MFN 08-251

Subject: **Response to Portion of NRC Request for Additional Information Letter Nos. 129 and 140 Related to ESBWR Design Certification Application - Auxiliary Systems - RAI Numbers 9.5-65, 9.5-67, 9.5-68 (NRC Letter No. 129), and 9.5-70 (NRC Letter No. 140)**

**Response to Portion of NRC Request for  
Additional Information Letter Nos. 129 and 140  
Related to ESBWR Design Certification Application**

Figure 9A.2-33. Site Fire Protection Zone ESBWR DCD Plot Plan

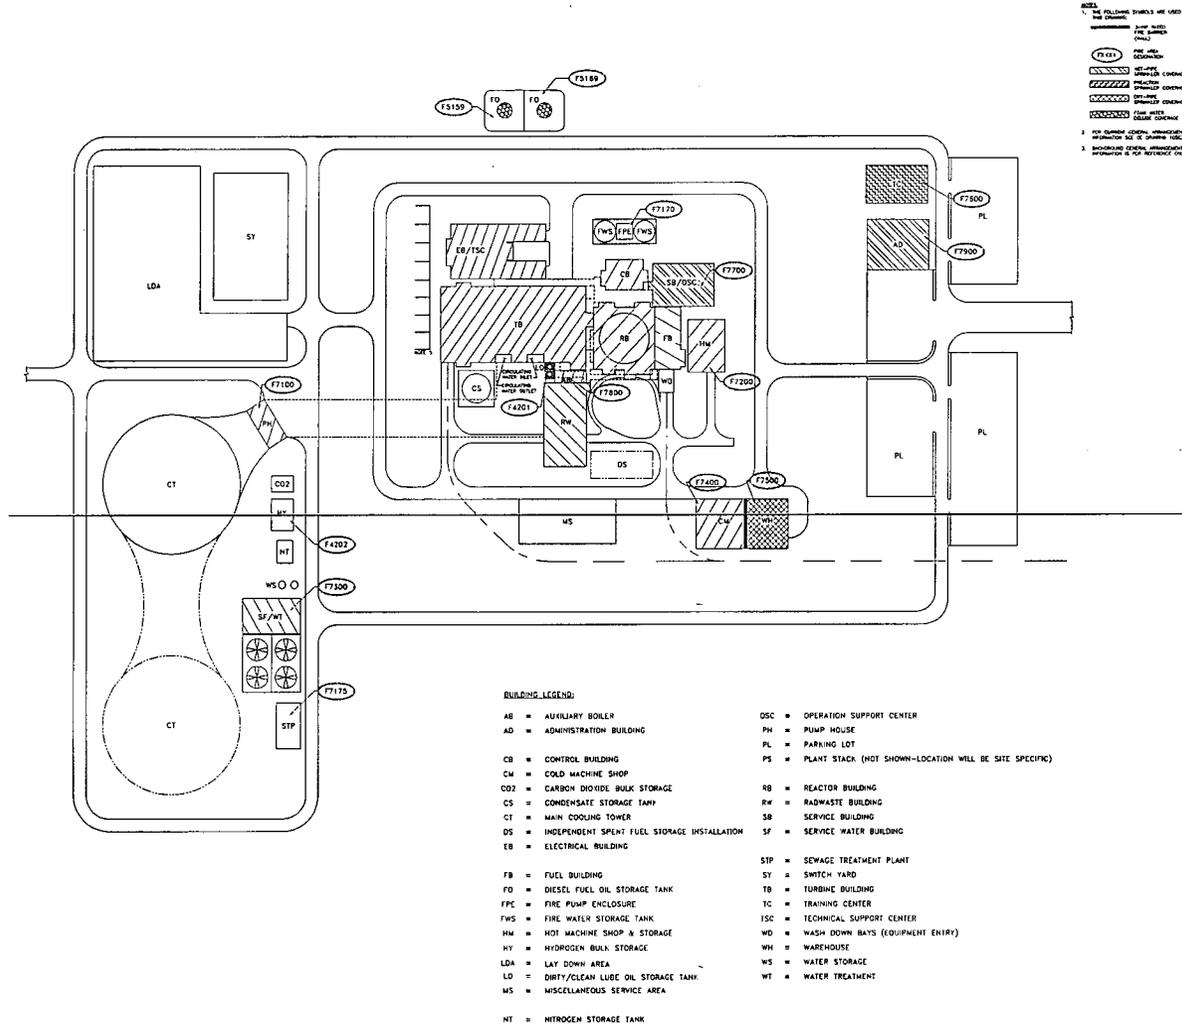
*DCD Tier 2, Revision 4, Figure 9A.2-33 identifies the fire pump enclosure as fire area F7170, whereas Table 9A.5-7 identifies the fire pump enclosure as fire area F8250 for electric fire pump A and fire area F8260 for diesel fire pump B. The DCD should be revised to provide consistent numbering for the fire pump fire areas. Figure 9A.2-33 also indicates a Note 5 near the transformers, but there are only three (3) notes in the figure legend, and they are numbered sequentially from 1 to 3.*

DCD Tier 2 Appendix 9A, Figure 9A.2-33, is revised in Revision 5 to delete fire area designator F7170 since there are multiple fire areas for equipment in the Fire Pump Enclosure (FPE) and it is not practical to designate several fire areas for this building on this Figure. Note 5 near the transformer area was undefined and therefore is removed in Revision 5 of DCD Tier 2 Appendix 9A, Figure 9A.2-33. There was no note 4 on DCD Revision 4.

Fire area designator F7170 and Note 5 are deleted from Figure 9A.2-33 of DCD Tier 2 Appendix 9A in Revision 5 as noted in attached mark-up.
